Accessibility Survey

City of Downey Gardendale Street & Barlin Avenue

Date of Inspection 2/2/2017

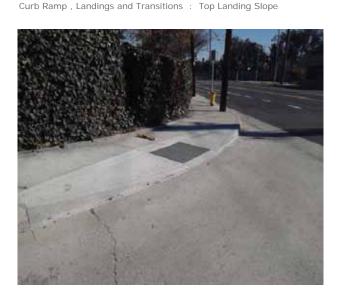
The slope at the top landing is greater than allowed.

On-Site Finding 2.70 percent

Provide a top landing surface that does not exceed the maximum slope and cross slope. Provide a sufficient maneuvering clearance that does not accumulate water.

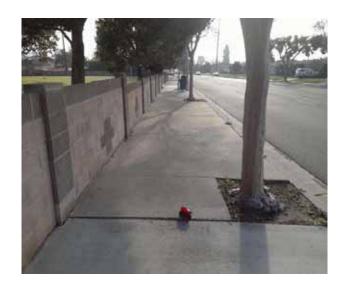
There is a change in elevation greater than recommended value.

On-Site Finding 0.50 inches

Ensure that the change in elevation is within the recommended value.

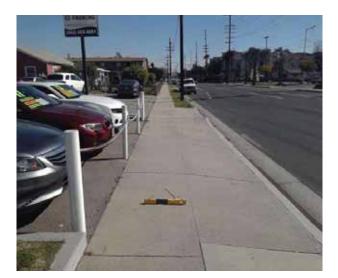
There are no detectable warnings where the pedestrian route crosses vehicular traffic.

On-Site Finding Not Found

Provide detectable warnings.

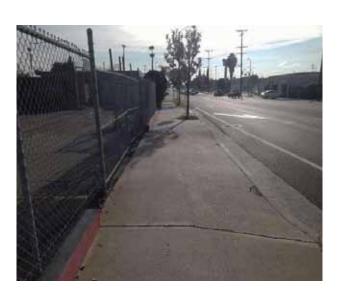
There are no detectable warnings where the pedestrian route crosses vehicular traffic.

On-Site Finding Not Found

Provide detectable warnings.

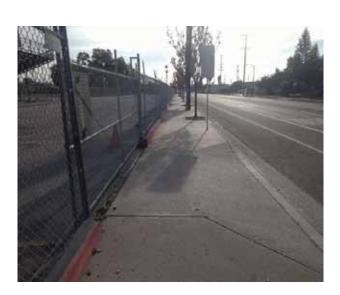
There are no detectable warnings where the pedestrian route crosses vehicular traffic.

On-Site Finding Not Found

Provide detectable warnings.

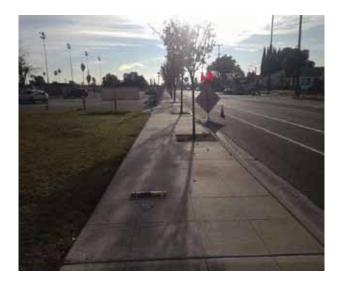
Sidewalk cross slope is not compliant.

On-Site Finding 2.70 percent for 44.00 feet

Repave the sidewalk surface with the recommended cross slope.

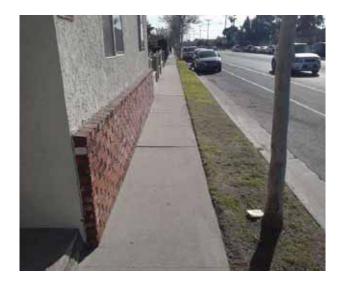
Sidewalk does not have enough width.

On-Site Finding 43.00 inches for 21.00 feet

Widen the sidewalk to the recommended value.

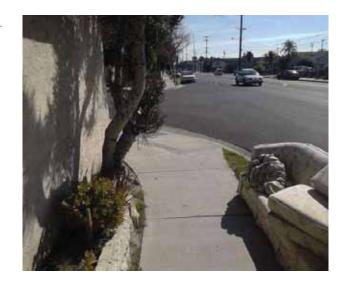
Overhead obstruction height is not compliant.

On-Site Finding 38.00 inches

Provide a compliant vertical clearance height.

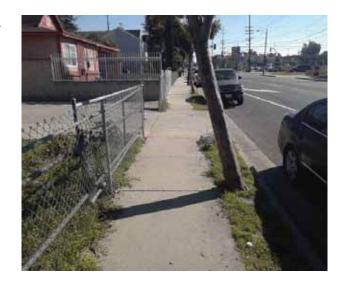
Overhead obstruction height is not compliant.

On-Site Finding 54.00 inches

Provide a compliant vertical clearance height.

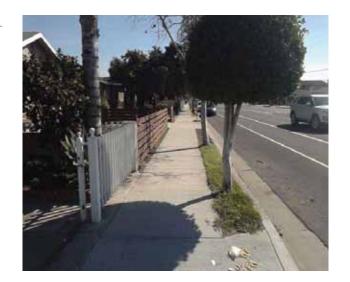
Overhead obstruction height is not compliant.

On-Site Finding 62.00 inches

Provide a compliant vertical clearance height.

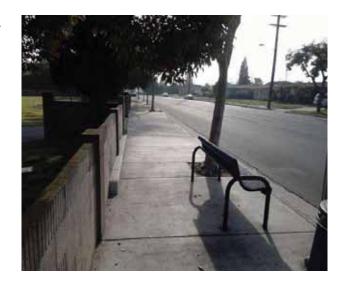
Overhead obstruction height is not compliant.

On-Site Finding 75.00 inches

Provide a compliant vertical clearance height.

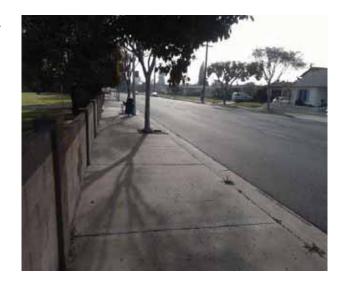
Overhead obstruction height is not compliant.

On-Site Finding 75.00 inches

Provide a compliant vertical clearance height.
